URGENT Medical Device Recall
AMALGATOME® SD, SDSYSTEM024
Item number: X101004, Amalgatome Pneumatic Hose

Website Posting of RN-1_X101004_Pneumatic Hose Notification

How do you recognize that the device may fail?

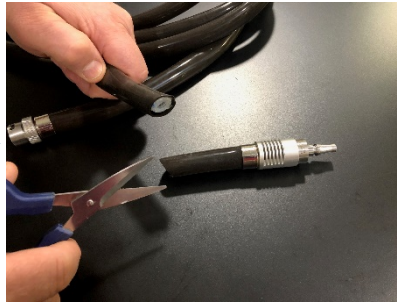
This recall has been initiated due to improper installation of the hand piece (bending hose at the proximal end and applying excessive force at the hose end fitting) by the user which results in a weakening of the internal hose connection to its end fitting. When improper installation occurs repeatedly, the hose connection may fail. The failure mode can result in the hose separation from the end fitting causing loss of pressure to the device or a hose burst or bulge.

The failure mode can result in the hose separation from the end fitting causing loss of pressure to the device or a hose burst or bulge.

1. Please immediately check your stock and quarantine impacted stock of hoses on hand to prevent further use. Replacement of newly designed hoses have been provided with this communication.
2. Review and complete the attached X101004_Pneumatic Hose Customer Response Card, by confirming the information that is listed; serial number(s) of the hose(s), and, check the box that you have received and understood the communication.
3. Upon verifying the information and completing the X101004_Pneumatic Hose Customer Response Card provide this to your Burn Account Manager. Please complete and return the enclosed response card as soon as possible.
4. Render the identified Item Number: X101004 Pneumatic Hose(s) unusable as pictured below. Replace inventory with newly designed hose(s) provided.
